**UNITED STATES  
NUCLEAR REGULATORY COMMISSION**

**SUBJECT: BRAIDWOOD STATION, UNITS 1 AND 2, NRC SPECIAL INSPECTION TEAM  
(SIT) REPORT 05000456/2010010; 05000457/2010010**

Report No: 05000456/2010010 and 05000457/2010010

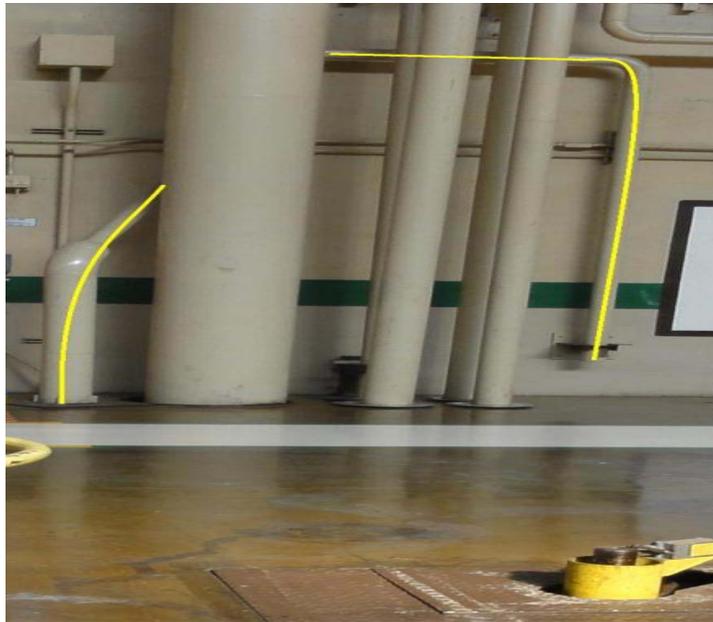
The AFW suction header includes two stand-pipes (or vent risers) used to attenuate AFW pumps suction pressure transients during pump startup by providing a source of water that is close to the pumps' suction and at a head equal to the water height in the condensate storage tank (CST). The CST is the preferred source of water to the AFW pumps. These transients occur because the motor-driven AFW pump accelerates at a higher rate than the water coming from the CST resulting in a temporary low suction pressure (assuming that the stand-pipes were isolated from the header). The high point on the stand-pipes is approximately 8.5 feet higher than the top of the CST. When the condenser hotwell high level setpoint is met, the hotwell overflow control valves open to transfer condensate reject to the CST via the condensate header using the CD/CB pumps. The condensate header communicates with the AFW suction header coming from the CST. When the flow rate of water rejected from the hotwell to the CST is greater than the discharge rate out of the AFW pumps, the level in the standpipe would increase and the conditions were great enough that water could spill onto the turbine deck, because the stand-pipes are open to the atmosphere on the common turbine building at the 451' elevation. The discharged water is able to flow through the floor and rain down the lower elevations through multiple openings in the floor. The team found that this occurrence was known to happen in multiple occasions in the past by the licensee without significant impact to the plant. However, on August 16, 2010, this occurrence caused the trip of Unit 1. As a result, one self-revealed finding of significance was identified, as discussed below.

Description: On August 25, 2010, the inspectors noted that the licensee failed to correct a condition that resulted in water to be discharged from Unit 2 to the common turbine building floor during reject of condensate from the Unit 2 condenser hotwell, which led to the reactor trip of Unit 1 on August 16, 2010.

The inspectors learned through interviews and discussions with plant personnel that water had been observed to discharge through the AFW stand-pipes on multiple occasions in the past. However, this occurrence was found to be captured in the CAP only on one occasion in 2009. In addition, the inspectors noted that the resolution of the issue captured in 2009 focused only on industrial safety and did not evaluate the impact of the water on plant equipment. This condition had not caused a reactor trip prior to the 2010 event.
